March 22, 2017

Re: WSPA Comments on ARB February 7, 2017 2nd Refinery Co-Processing Working Session

Figure 7. Process level energy inputs, outputs and CO₂ emissions for illustrating process unit level energy and CO₂ allocation

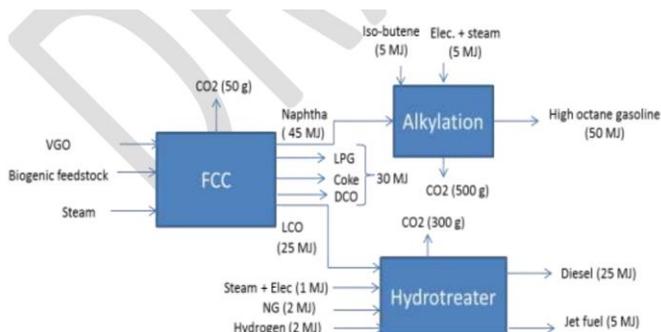
It is also suggested that ARB use more realistic refining process schematics when developing illustrations and examples in support of the various allocation methods. For example, Figure 7 of Discussion Paper shows the FCC naphtha intermediate being routed to an alkylation unit to produce high octane gasoline which is not the case. This schematic is further discussed in a subsequent comment. A useful reference regarding process schematics is “*Petroleum Refining: Technology and Economics*”².

WSPA believes that the treatment of Alkylation in co-processing models needs to represent actual refinery operations. Alkylation is mentioned in several instances in the Discussion Paper. As shown in Figure 7 (below), the Discussion Paper presents a potentially confusing schematic (as noted in a previous comment) where one could assume that the naphtha from the effluent of the FCC unit is injected into an alkylation unit and reacts with petroleum-based isobutene to form alkylates (high octane gasoline blend stocks). The LPG stream from the FCC unit is treated as a finished product and sold as a NG substitute for its energy content.

In reality, olefin feed from an FCC unit’s Unsaturated Gas Plant (butylene, propylene, amylene) is directed to the Alkylation Unit which also receives isobutene feedstock (some from the FCC but mostly imported). The C7-C9 paraffinic alkylate product is a gasoline blendstock directed to finished product blending. Since the LPG stream from the FCC effluent is typically sent to the alkylation unit and converted to premium gasoline blend stock, the assumption that it will be sold as a process fuel product is inappropriate.
